# Access Compliance Report

## Public Rights-of-Way

Intersection ID: 10035338	Main Street: RAIL_CROSSING_LN	Cross Street: N/A	Location: NW
ADA ID: 4EC59CF17508	Ramp Type: Perp	Initial Pass/Fail: Fail	Overall Compliance: No
		Severity Score: 25

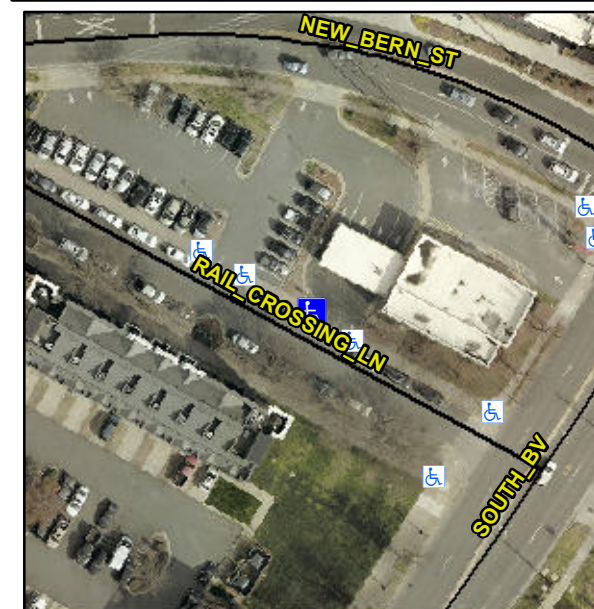
**Not Found, R304.5.3**

Compliance	Description	Data	Compliance	Description	Data
N/A	Ramp Length (in)	56.0	Yes	Ramp Slope (%)	6.8
Yes	Ramp Width (in)	54.0	No	Ramp XSlope (%)	11.2
N/A	Flare Type LT	N/A	N/A	Flare Type RT	N/A
N/A	Flare Slope LT (%)	N/A	N/A	Flare Slope RT (%)	N/A
N/A	Flare Traversable LT?	N/A	N/A	Flare Traversable RT?	N/A
N/A	Landing Length (in)	N/A	N/A	DWS Provided?	N/A
N/A	Landing Width (in)	N/A	N/A	DWS Contrast?	N/A
N/A	Landing Slope (%)	N/A	N/A	DWS Length (in)	N/A
N/A	Landing X Slope (%)	N/A	N/A	DWS Full Width?	N/A
N/A	Landing Curb? (Y/N)	N/A	N/A	DWS Offset (in)	N/A
N/A	Shared Landing?	N/A			
N/A	Gutter Ponding?	N/A	N/A	Gutter Slope (%)	N/A
N/A	Gutter Lip Ht (in)	N/A	N/A	Gutter X Slope (%)	N/A
N/A	Painted X Walk1?	No	N/A	Painted X Walk2?	N/A
	X Walk 1 Direction	To SE		X Walk 2 Direction	N/A
N/A	X Walk 1 Width (in)	N/A	N/A	X Walk 2 Width (in)	N/A
	X Walk 1 Slope (%)	2.2		X Walk 2 Slope (%)	N/A
	X Walk 1 X Slope (%)	7.3		X Walk 2 X Slope (%)	N/A

**Remove & Replace Entire Ramp.**
